# HIGHWAY WORK PROPOSAL

<u>COUNTY</u>	<u>STATE PROJECT</u>	<u>FEDERAL</u>	<u>PROJECT DESCRIPTION</u>	<u>HIGHWAY</u>
Brown	4327-08-71	N/A	V Denmark, CTH R; Devils River Trail Bridge B-05-0438	CTH R
Brown	4327-09-71	N/A	V Denmark, CTH R; S Wall Street Bridge B-05-0439	CTH R

Addendum No. 01  
ID 4327-08-71  
Revised Sheet 60  
January 8, 2020

Addendum No. 01  
ID 4327-09-71  
Revised Sheet 10  
January 8, 2020

STATE OF WISCONSIN DEPARTMENT OF TRANSPORTATION	
STRUCTURE B-5-438	BY
QUANTITIES, TYPICAL SECTION, & DESIGN DATA	PLANS - C.B.S./C.B.M. BY C.B.S./C.B.M.
SHEET 2 OF 23	
60

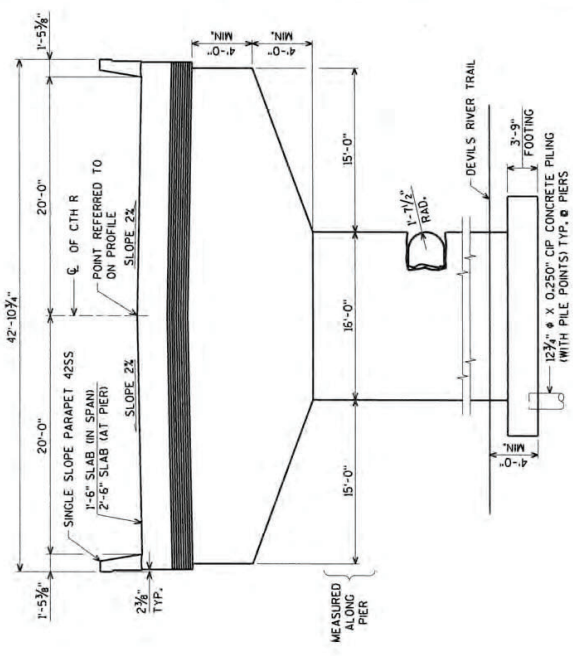
Revised Plan Sheets	
Plan Sheet	Plan Sheet Title (brief description of changes to sheet)
60 (60)	Quantities, Typical Section, & Design Data (Revised quantity for Pipe Underdrain 6-Inch for project 4327-08-71)
10 (98)	Miscellaneous Quantities (Added items Removing Small Pipe Culverts and Removing Concrete Slope Paving for project 4327-09-71)
69 (157)	General Plan (Revised Slope Paving for project 4327-09-71)
70 (158)	Quantities, Typical Section, & Design Data (Revised quantity for Pipe Underdrain 6-Inch and Slope Paving Concrete for project 4327-09-71)

NO.	DATE	REVISION	BY
01-20		ADD PIPE UNDERDRAIN AT SLOPE PAVING	AYRES

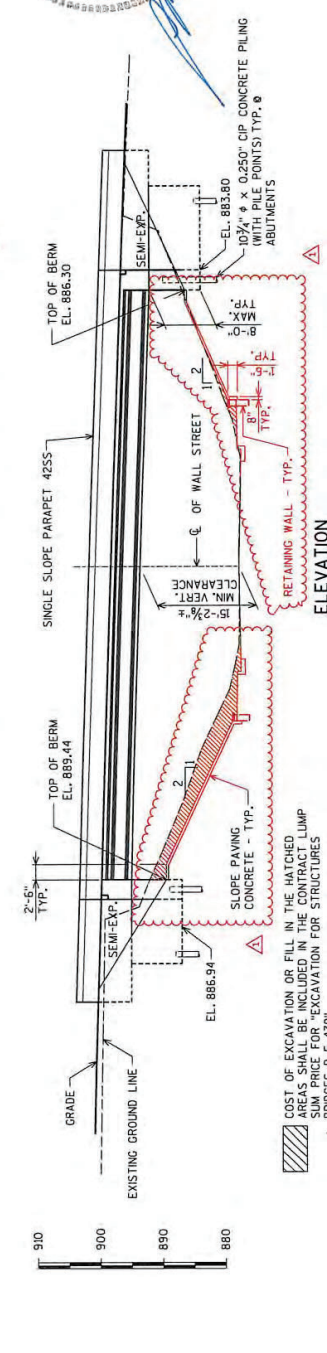
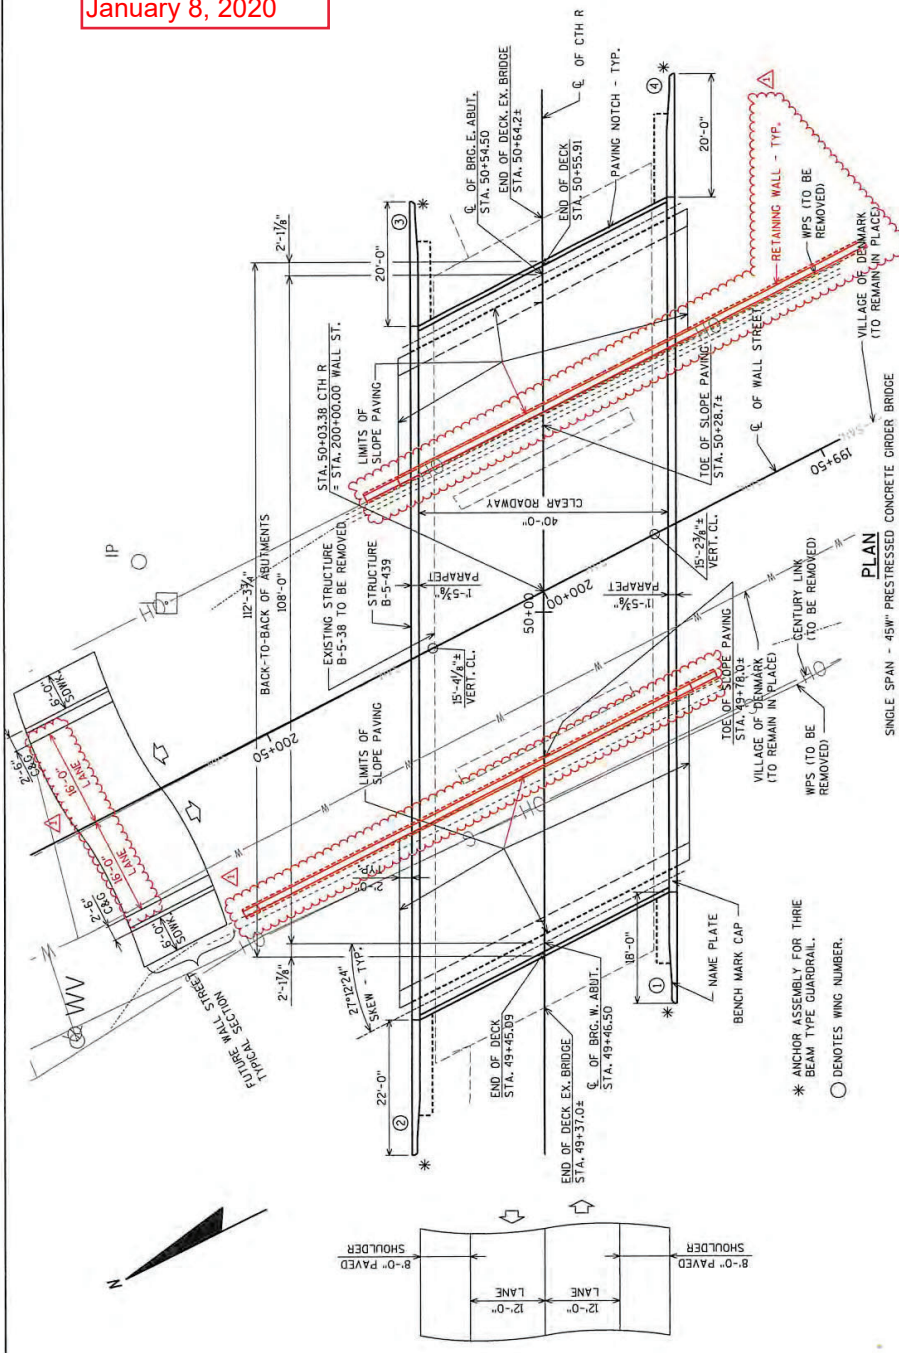
NO.	DATE	ADD	REVISION	WALLS	AYRES	BY
8

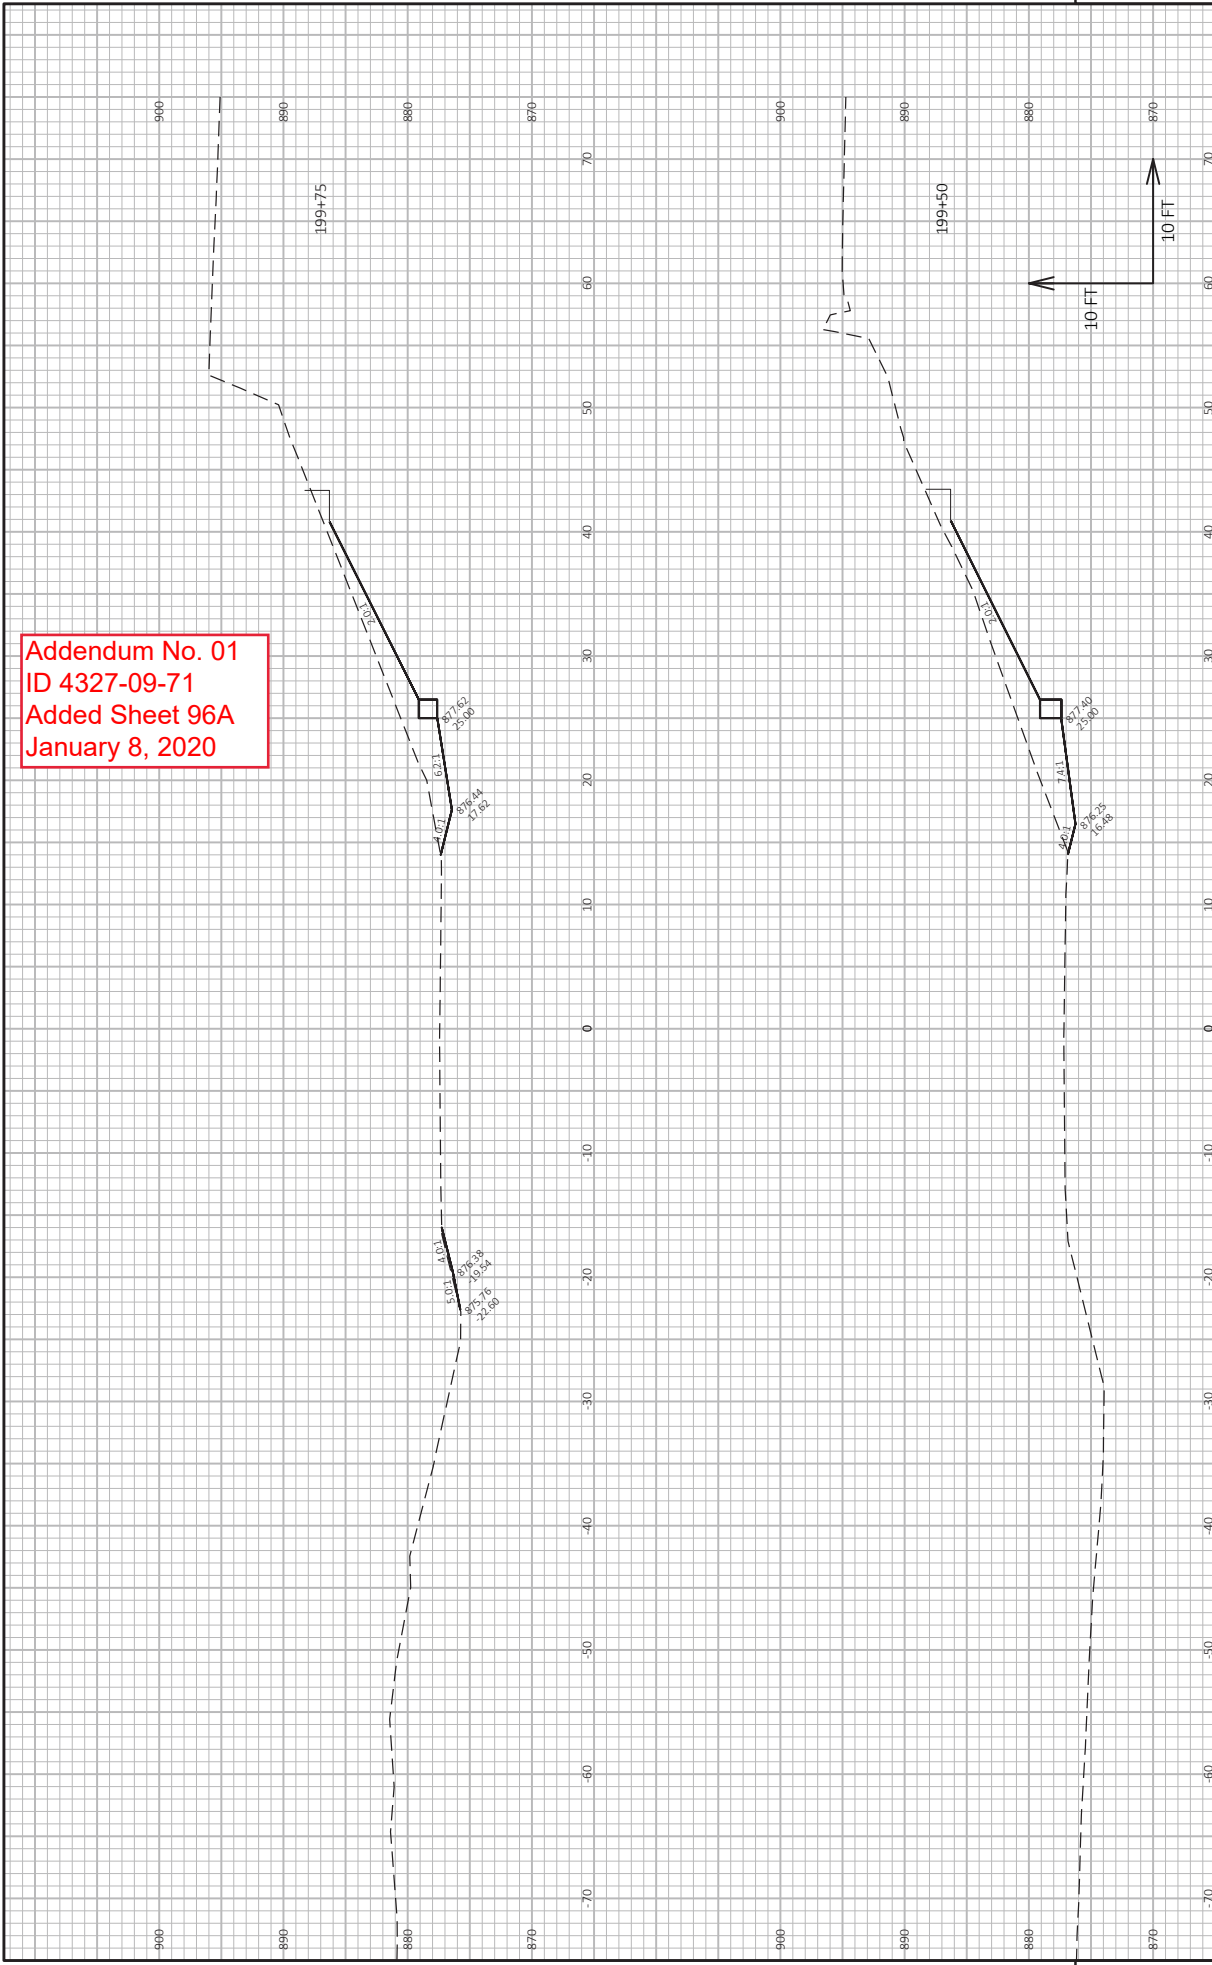
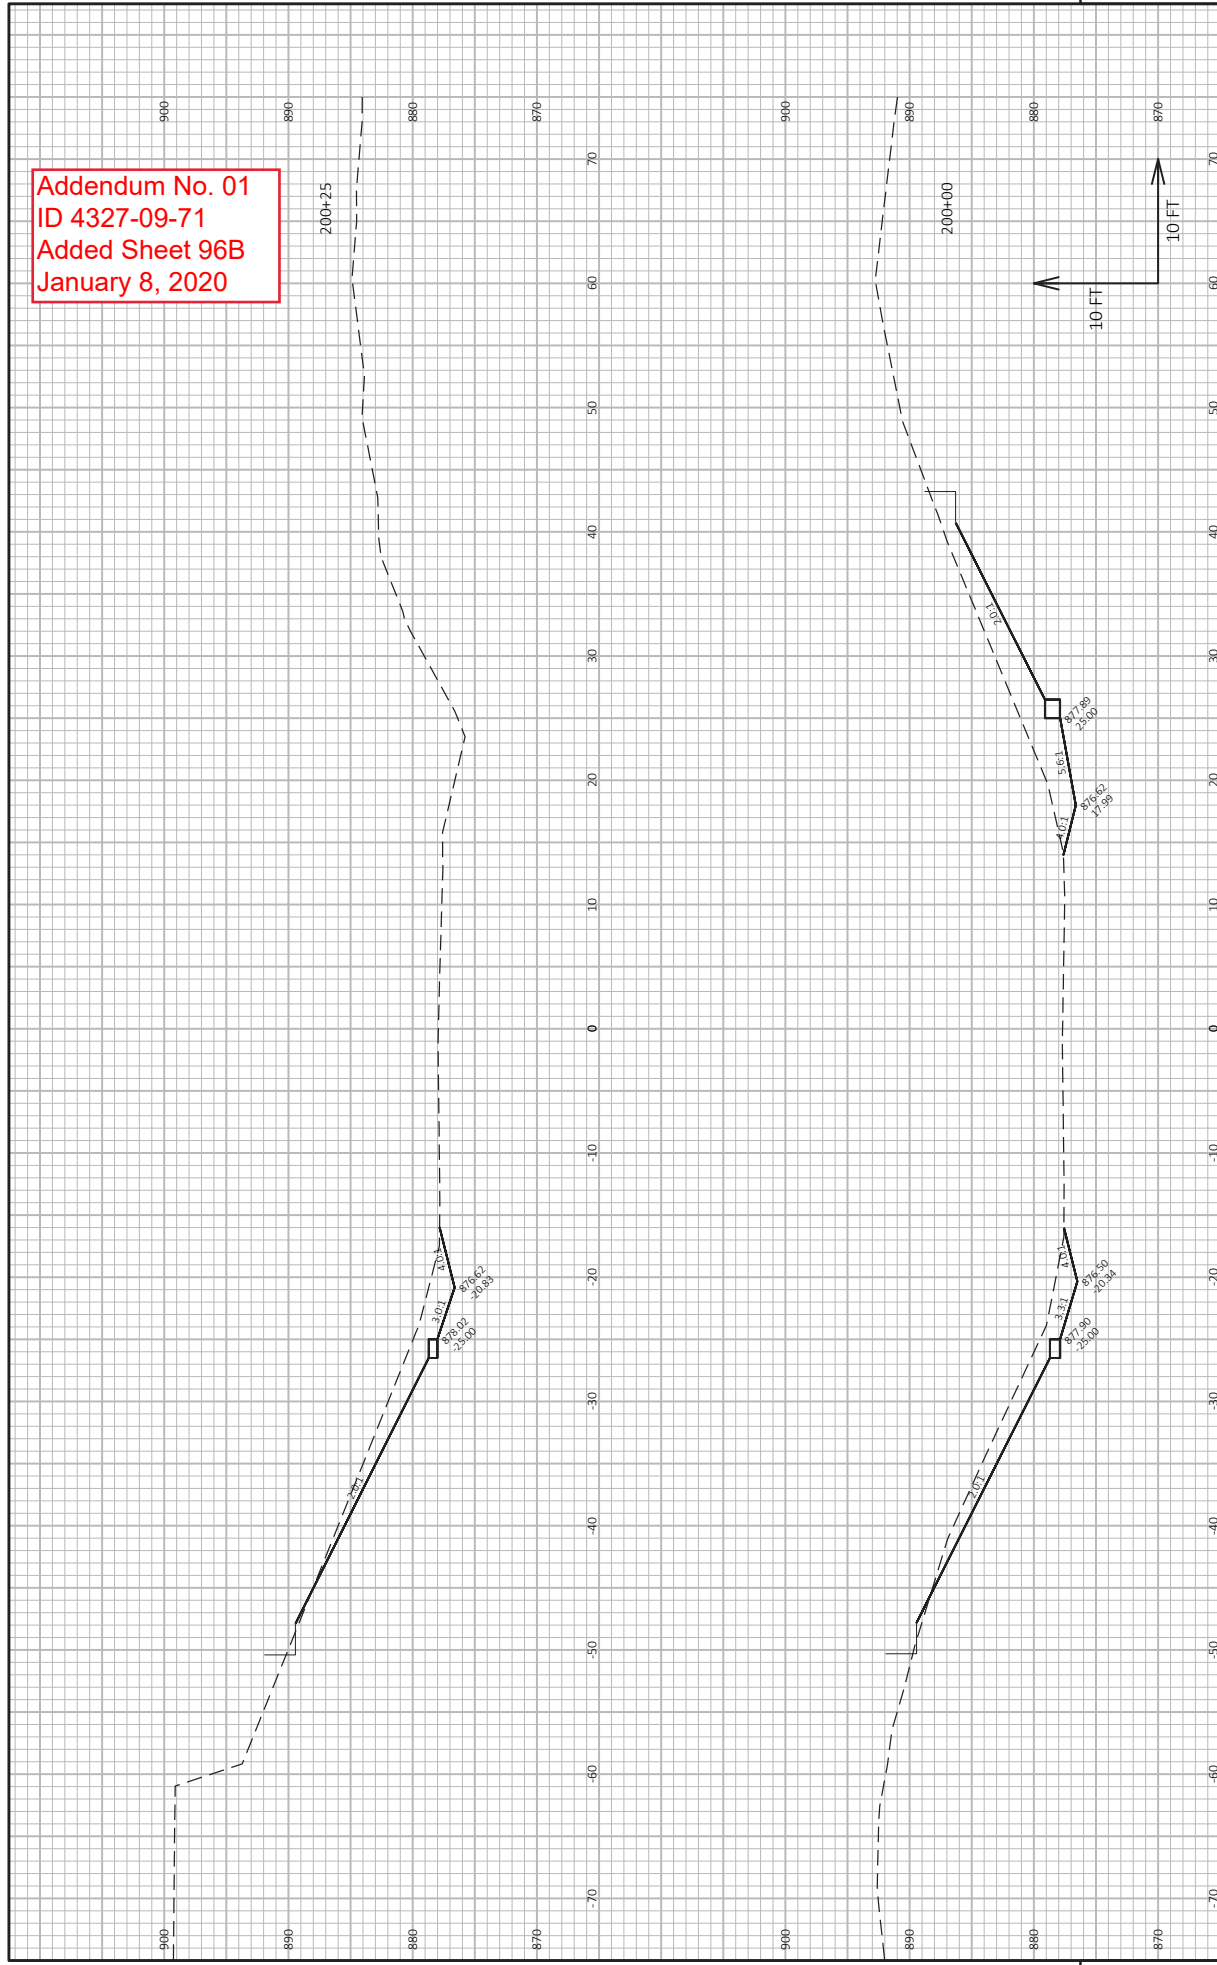
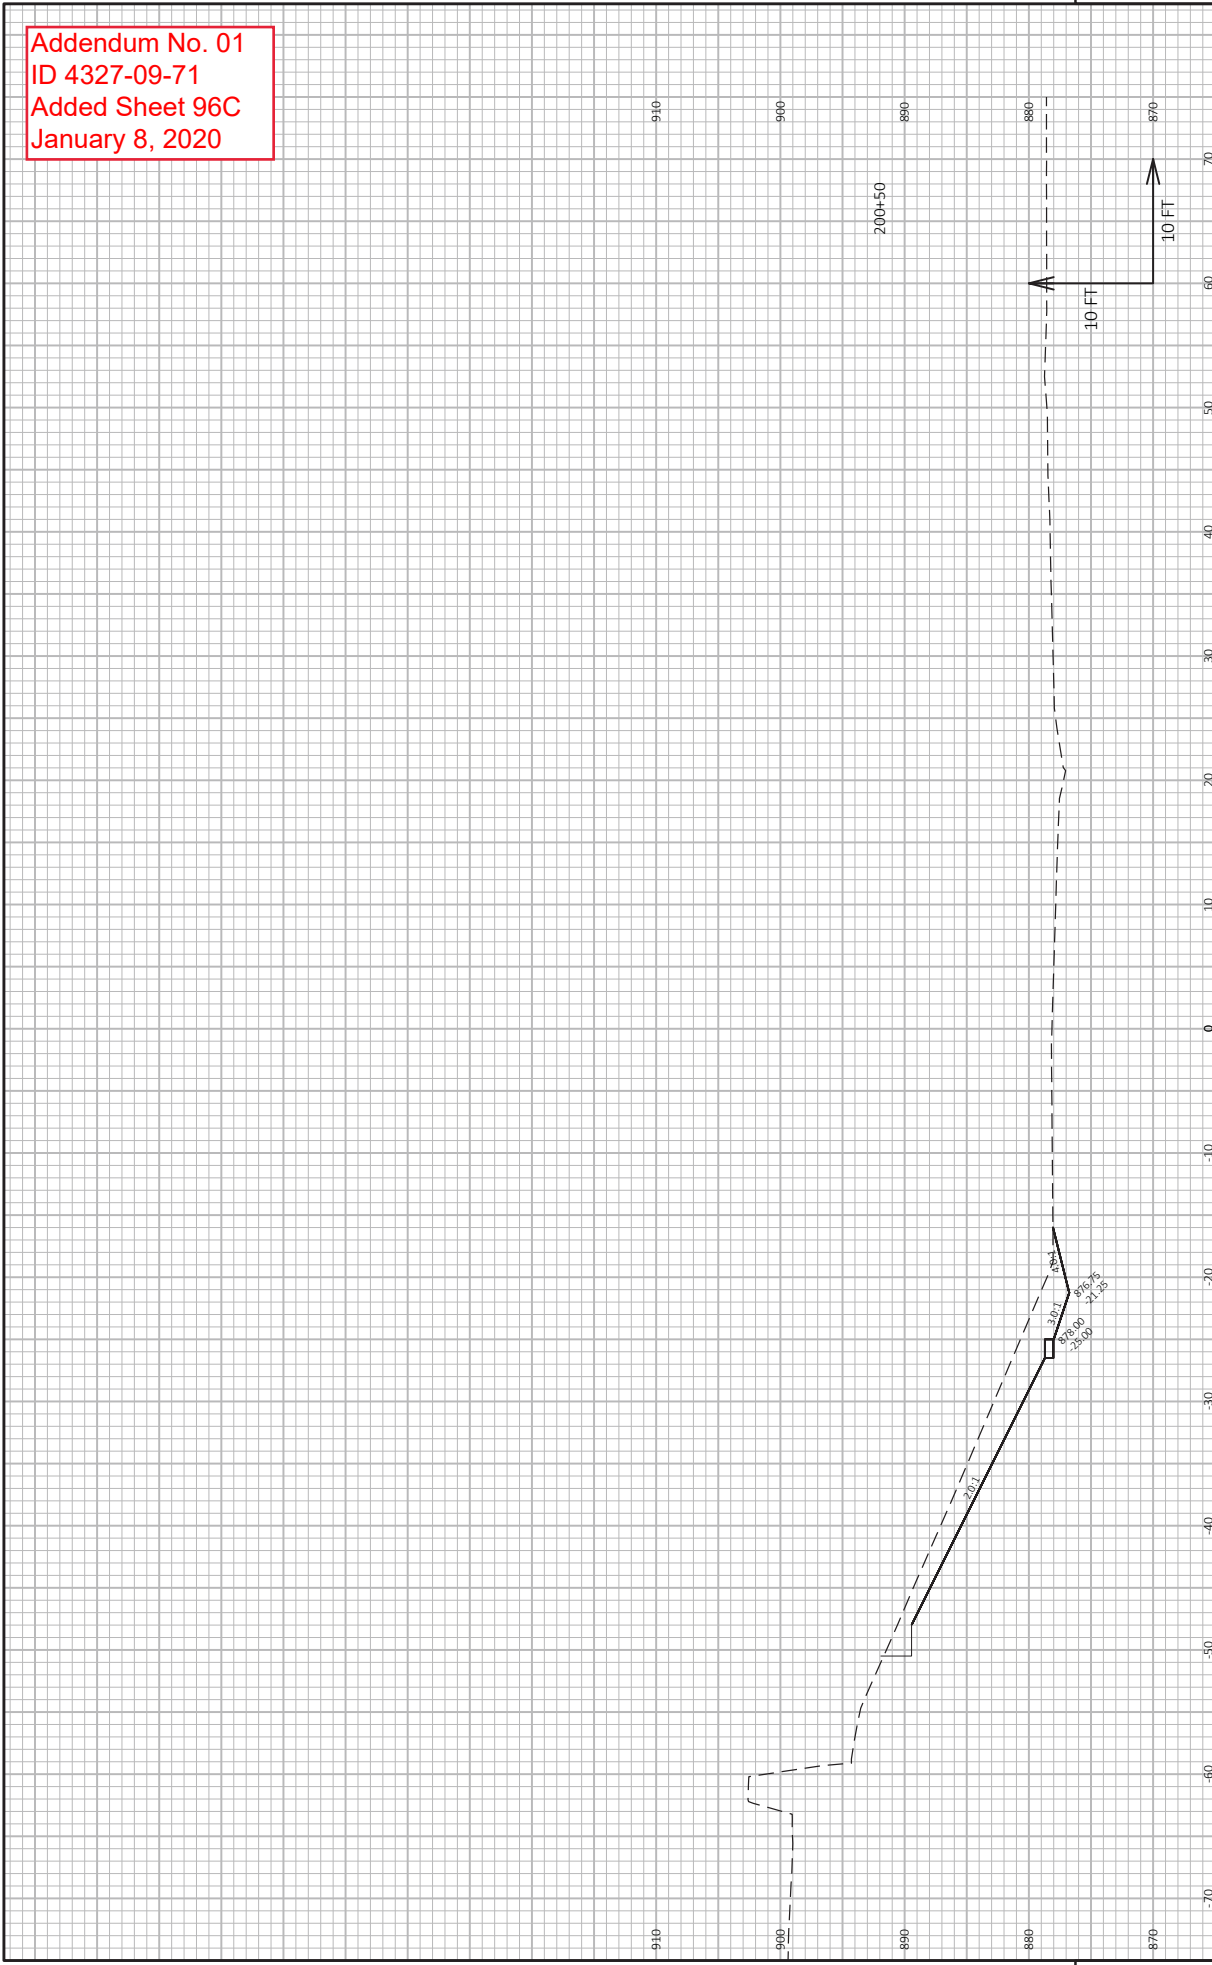
<b>Added Plan Sheets</b>	
<b>Plan Sheet</b>	<b>Plan Sheet Title (brief description of changes to sheet)</b>
96A	Cross section sheet under Bridge B-05-0439 along Wall Street
96B	Cross section sheet under Bridge B-05-0439 along Wall Street
96C	Cross section sheet under Bridge B-05-0439 along Wall Street

**Addendum No. 02**  
**ID 4327-09-71**  
**Added Sheet 4B**  
**January 9, 2020**

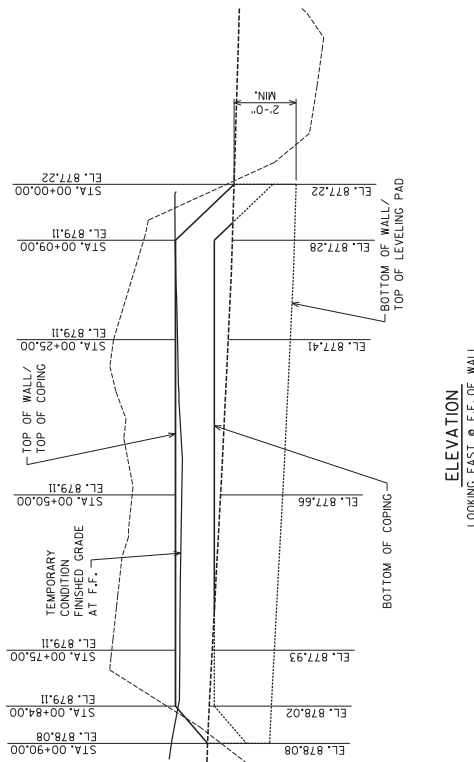
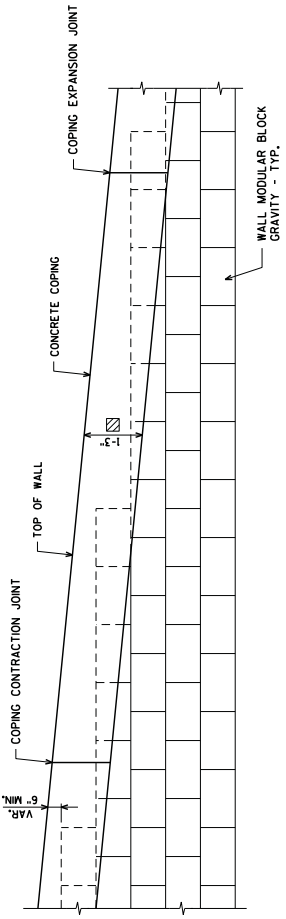
The following 8½ x 11-inch sheets are attached and made part of the plans for this proposal:  
Project 4327-09-71: Added: 4A, 4B, 4C and 4D

ITEM NUMBER	BID ITEMS	UNIT
612.0406	PIPE UNDERDRAIN WRAPPED 6-INCH	110 LF
SPV.0165.02	WALL MODULAR BLOCK GRAVITY LANDSCAPE EAST ABUTMENT	305 SF

DESIGN RETAINING WALL FOR A LIVE LOAD SURCHARGE OF 240 psf.
